Figure correction in service manuals

The unbalanced connection diagram in the Test Procedures section of the Panaray (502) service manual, P/N 170310, and in the 402/802 II service manual, P/N 174785, is incorrect. **Figure 19 on page 33** of the 502 service manual and **Figure 24 on page 23** in the 402/802 II service manual should be changed as follows (only a partial figure is shown):

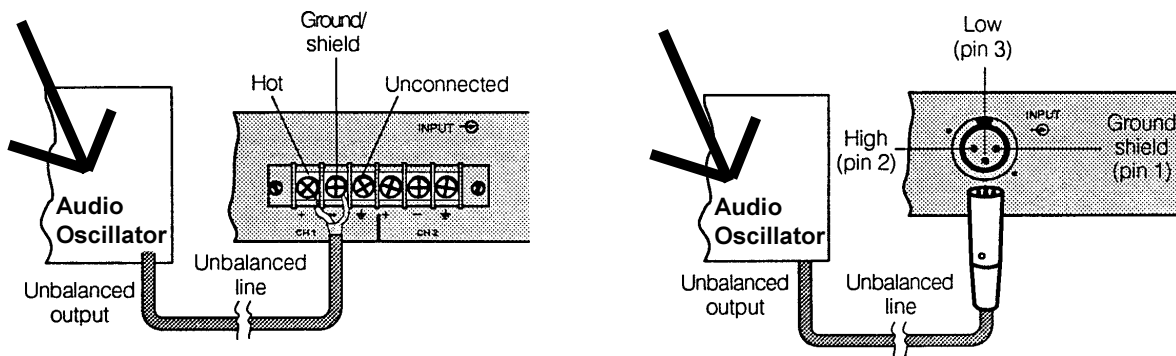
The input device was incorrectly identified as an amplifier. It should be a signal generator or audio oscillator.
